STARTUP ZONE

USB DATA LOGGING SYSTEM

Correct power supply connections for VNC1L-1A

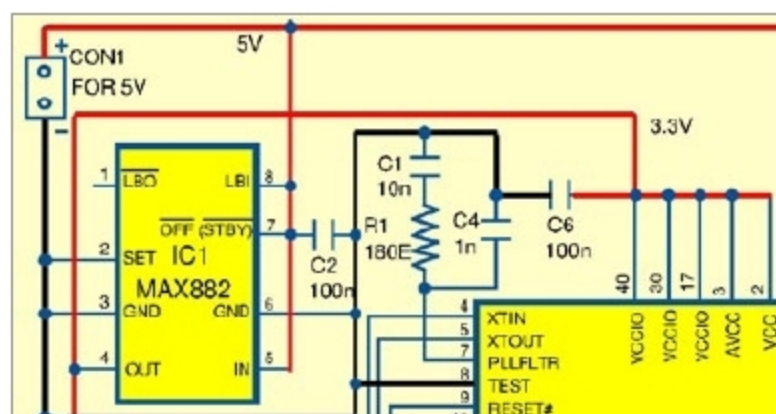
This is regarding 'Build A Real-Time USB Data Logging System' DIY article published in November issue. Datasheet of VNC1L-1A chip shows maximum supply voltage of +3.6V but in the circuit you have connected +5V to this chip. Kindly clarify.

You are correct! Supply voltage of VNC1L-1A (IC3) should be 3.3V. The purpose of using MAX882 (IC1) is to provide 3.3V for VNC1L-1A. Please connect pins 40, 30, 17, 3 and 2 of IC3 to 3.3V output pin 4 of IC1 as shown in figure below.
